# Clarification on MIMO Feedback Measurement and Report (P80216m/D3-16.3.6.5.2.4.5)

Document Number: IEEE C802.16m-09\_2822r1

Re : IEEE 802.16-09/0073, “IEEE 802.16 Working Group Letter Ballot#30b”

Target topic: “IEEE P802.16m/D3 section 16.3.6.5.2.4.5 ”.

Fig. 2. Time varying fading channels and the predicted channel responses for mobile speeds: (a) 3 km/h, (b) 10 km/h.

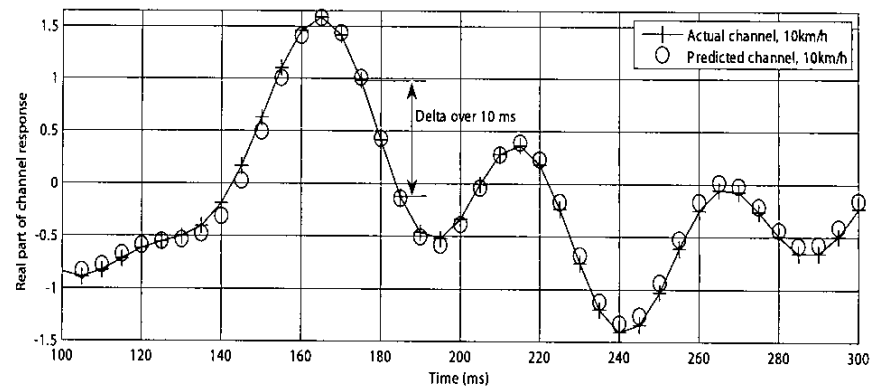
## ● Impact of time varying channels on MIMO Feedback Measurements

- ❖ The channel correlation between frames may be deteriorated due to channel variation in association with the speed.
- ❖ The tolerable delay for acceptable channel prediction and MIMO feedback measurement performance is about 2 frames.
